**CORRIGENDUM No. - 8
NIT No. 01(2016-17)/EE (Project) W-II**

(EXTENSION OF BID SUBMISSION DATES & REPLY TO CLARIFICATIONS)

Name of Work :- Design, Construction, Installation, Testing, Commissioning and Automation with 2 years DNP and 14 years O&M of 477 MLD Chandrawal Water Treatment Plant including Up gradation and Implementation of Part Existing Units and Central Water Management Centre

CLARIFICATION TO PRE-BID QUERIES – II (Dated 26.04.2017) R1

H. Elevations (Transmission Network Pkg 3)

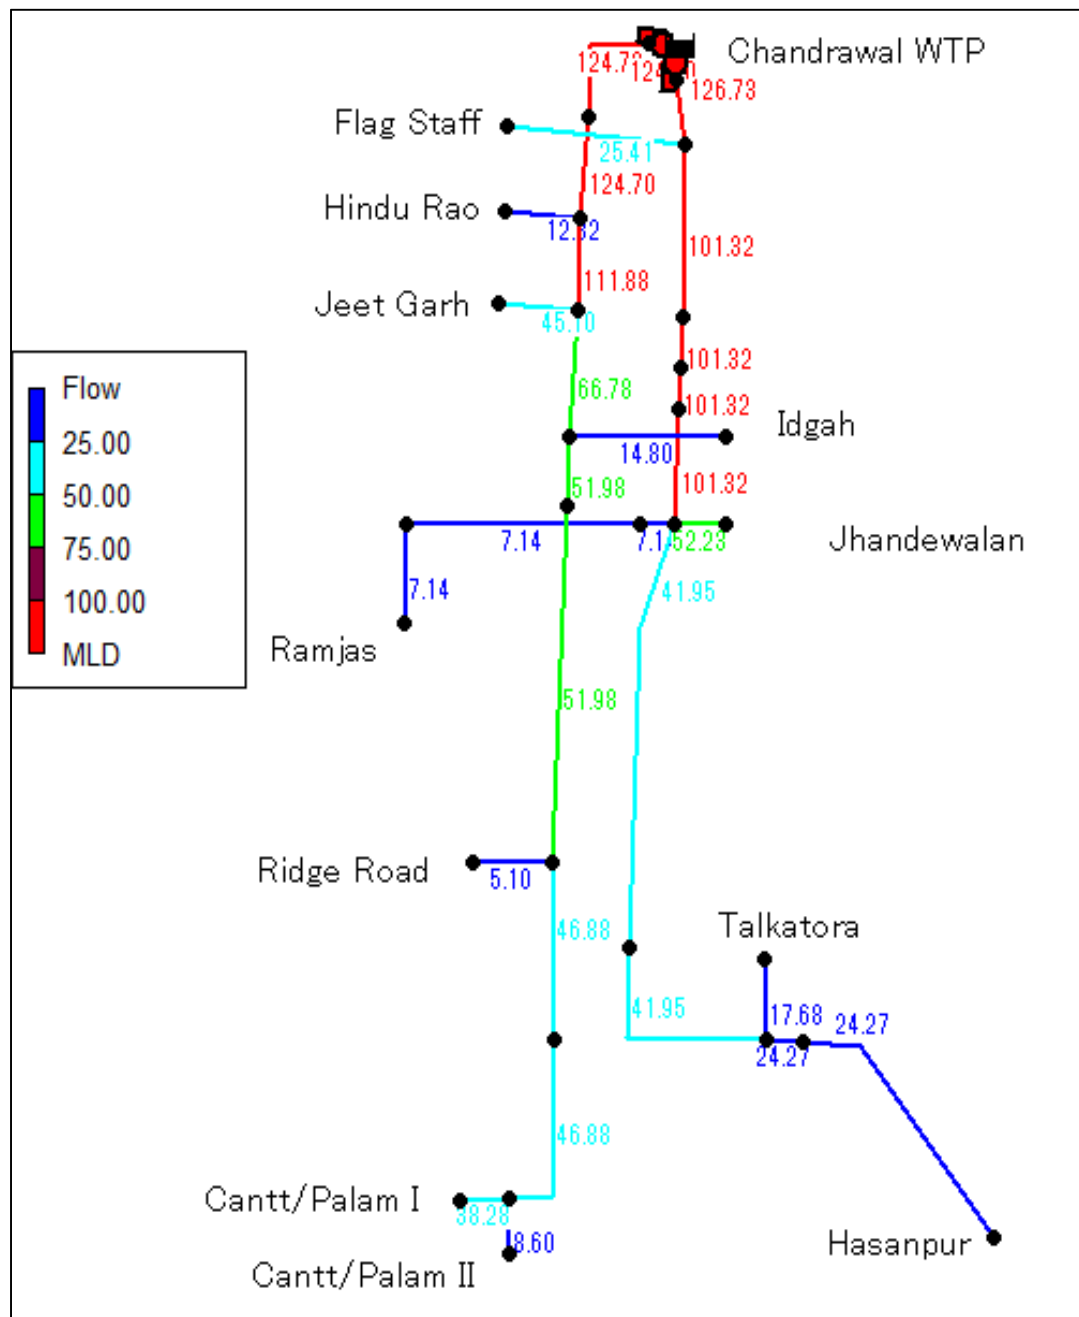
Line 1 (down to Cantt Palam): 125 MLD, 63 m head; Line 2 (down to Hasanpur): 127 MLD, 52 m head

J. Elevations (Transmission Network Pkg 2)

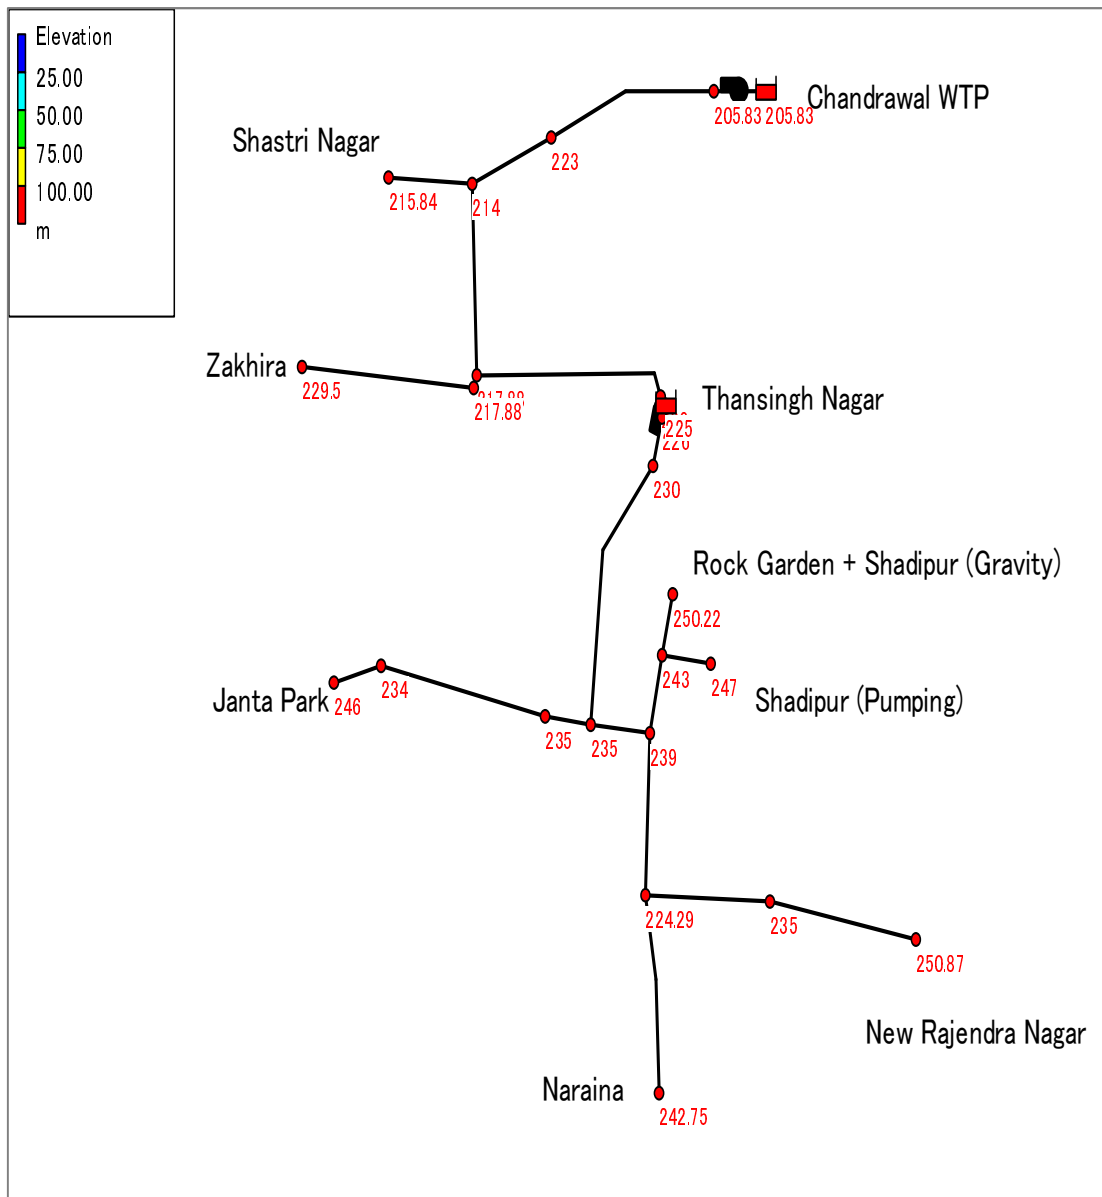
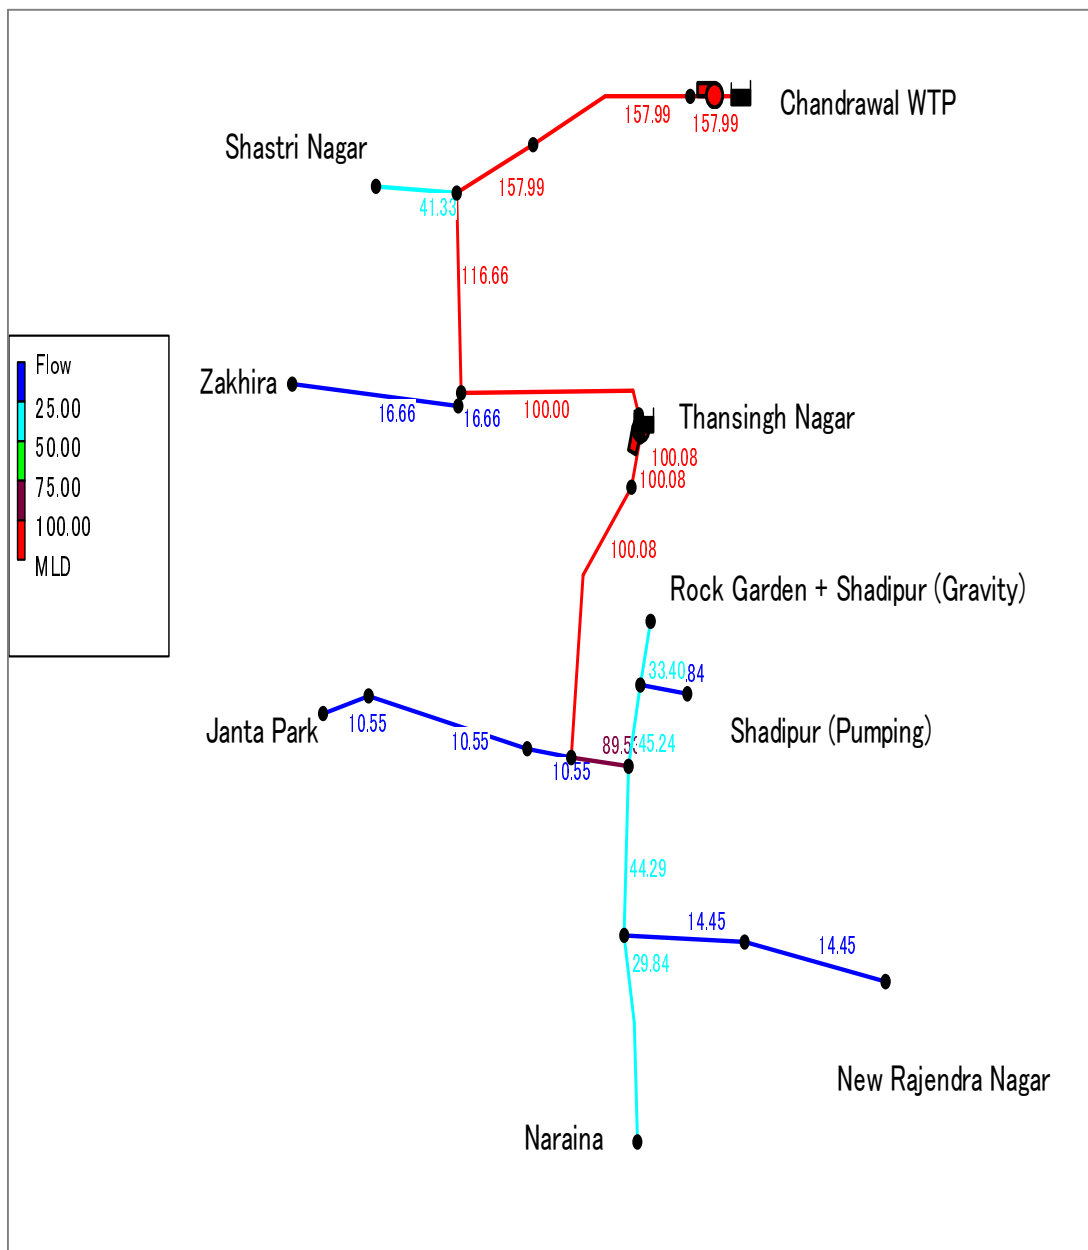
Pump at WTP: 158 MLD, 34 m head

Pump at Thansingh Nagar: 100 MLD, 33 m head

L. Elevations (Transmission Network Pkg 4)

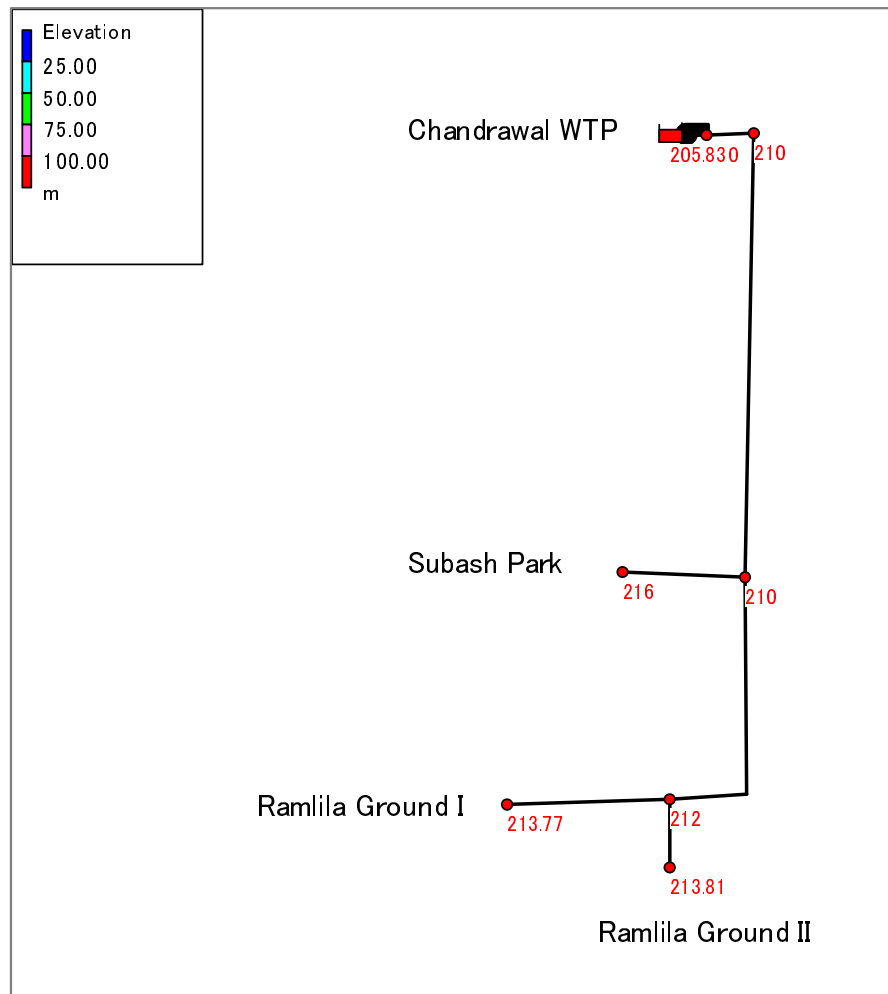
Pump at WTP: 68 MLD, 25 m head
